GOLD BAR MINE PROJECT DEIS ASSESSMENT

This is an assessment of the Gold Bar Mine Project DEIS by the Nevada Sagebrush Ecosystem Program (SEP). This assessment is in response to the Nevada Sagebrush Ecosystem Council's (SEC) request at the March 3, 2017 SEC meeting for the SEP to compare the proposed mitigation in the Gold Bar Mine Project DEIS to the mitigation that would be generated by using the Nevada Conservation Credit System (Credit System) to offset the impact of the Gold Bar Mine Project.

Figure 1: Gold Bar Mine Project Pre-Project Local-Scale Habitat Quality

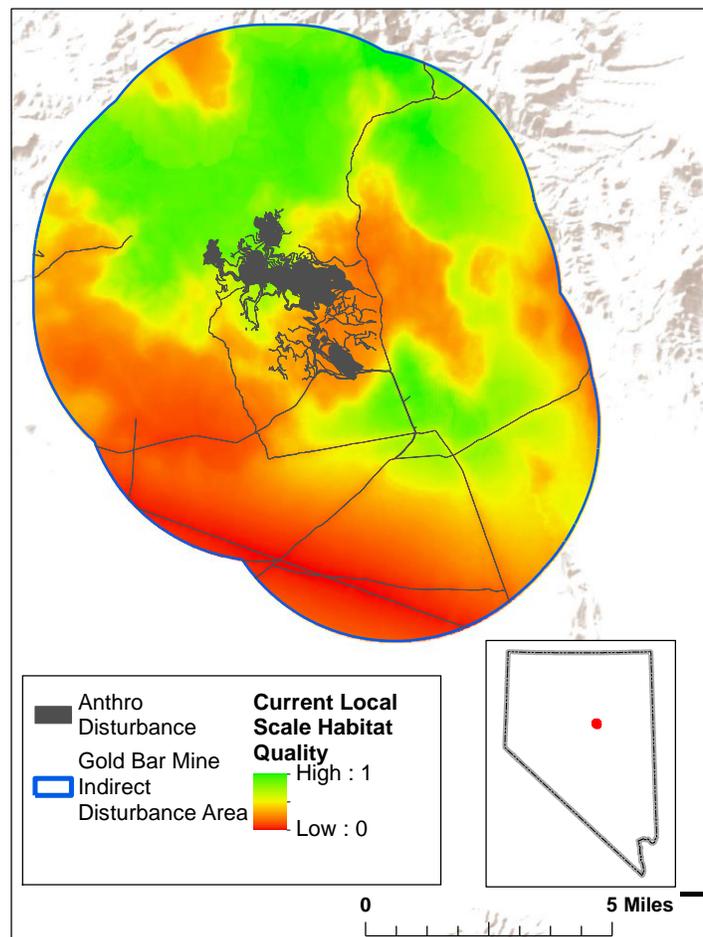
Figure 1 illustrates the pre-project local-scale habitat quality within the area indirectly effected by the Gold Bar Mine Project. The total area indirectly effected by the Gold Bar Mine Project is 69,300 acres. Roughly 1/2 of the area indirectly effected by the Gold Bar Mine Project comprises relatively low quality habitat due to conifer cover and the existing disturbance (center of indirect effect area), while approximately 1/2 of the area indirectly effected by the Gold Bar Mine Project comprises relatively high quality habitat.

The Gold Bar Mine Project will generate 6,200 debits when assessed using the most recent version of the Conservation Credit System Habitat Quantification Tool (HQT), which includes the improvements approved by the SEC in January and March 2017. This debit estimate utilizes field data collected in 2016 in order to assess the site-scale habitat function.

Figure 2: 3 Bar Ecosystem and Landscape Restoration Project Area Local-Scale Habitat Quality

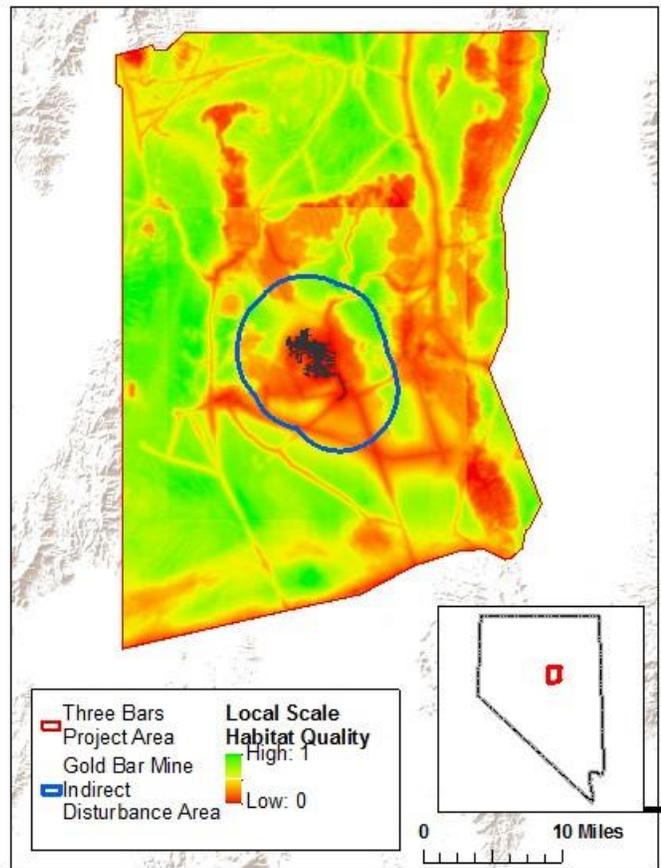
Figure 2 illustrates the local-scale habitat quality within the 3 Bars Project area, including the indirect effects from the proposed Gold Bar Mine Project.

There are opportunities to generate a meaningful number of credits from improving and protecting habitat within the 3 Bars Project area. However, some mitigation activities in areas with or adjacent to substantial existing pinyon juniper and anthropogenic disturbances, such as the central and east sections of the 3 Bars Project area, would potentially generate minimal credits and could potentially create a population sink due to subsidized predation, particularly as populations move between seasonal habitat types. Strategic placement of conservation activities would need to be carefully planned.
